IN THE MATTER of Proposed Plan Change 20 – Airport Northern
Precinct Extension to the Operative Waipā
District Plan

REBUTTAL STATEMENT OF EVIDENCE OF CAMERON BESWICK INDER

(TRANSPORT)

10 March 2023

Figure 1

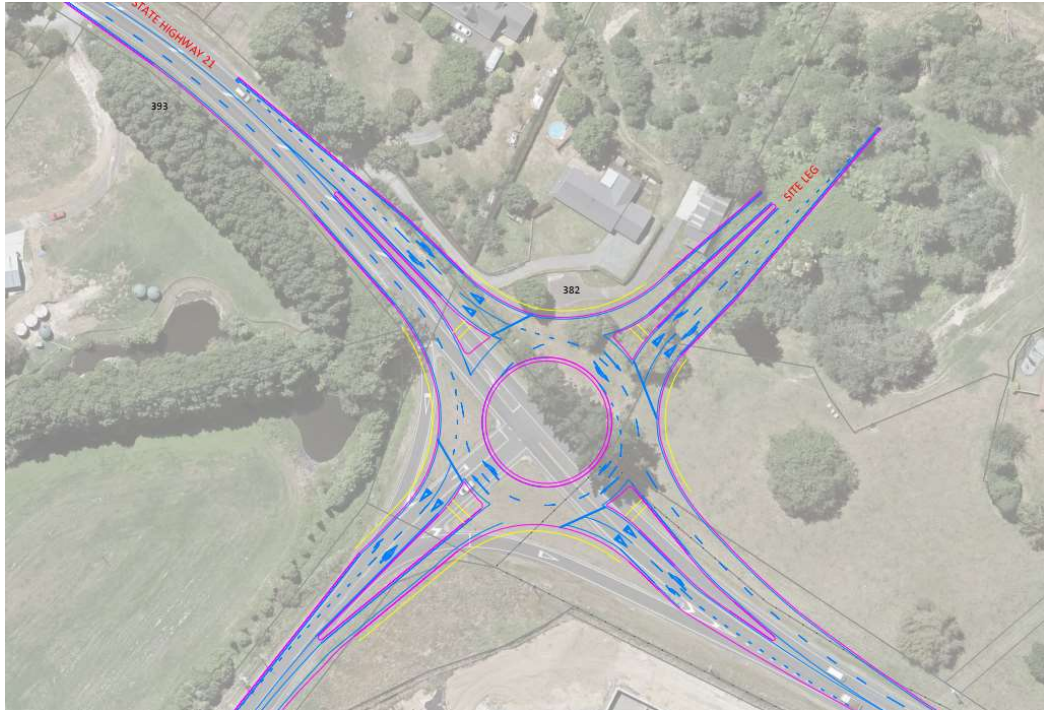
48. While Ms Makinson has demonstrated how a four-arm roundabout could be accommodated in Annexure A to her evidence, I note this design requires a significant

area of land from the owners east of SH21. Figure 1 is a copy of the plan for ease of reference.

49. I note in this concept plan that the design impinges quite significantly on a shed-like building and also the driveway of #382. The indicative new road reserve boundary is not shown but it would impact further into the property than the roundabout edge line shown.

50. I hold concerns with Ms Markinson's design as it could frustrate PC20 because it could not be built initially as a three-arm roundabout in that location without impacting land to be provided by the landowners at no cost to the parties building the roundabout. It is also unclear to me how certain the necessary land could be made available at the time the roundabout is to be constructed such that 'enabling' the fourth arm does not in-turn frustrate the PC20 development programme or add costs, or similarly delay Waka Kotahi's safety upgrade of the intersection when their funding becomes available. Therefore, I do not support the wording Mr Chrisp proposed for rule 10.4.2.13A in the Joint Witness Statement.
51. I note Mr Chrisp in his evidence, has instead proposed an advice note on proposed rule 10.4.2.13A which reads:

52. Firstly, although obvious, I note consultation should also be with Waka Kotahi. Aside from that, if it was recommended that an advice note was to be accepted, I consider it needs amendment to recognise this is “...subject to the necessary land required for enabling a fourth arm, being available to Waka Kotahi at no cost, at the time of design of the intersection upgrade”. Also, as the fourth arm of the roundabout is not required for PC20, the cost of the requirement to ‘enable’ the future upgrade of the roundabout should not fall on any non-benefiting party.
53. I defer to Mr Grala’s response in paragraph 53 and 54 of his evidence, as to whether an advice note to this effect should be included in a district plan.
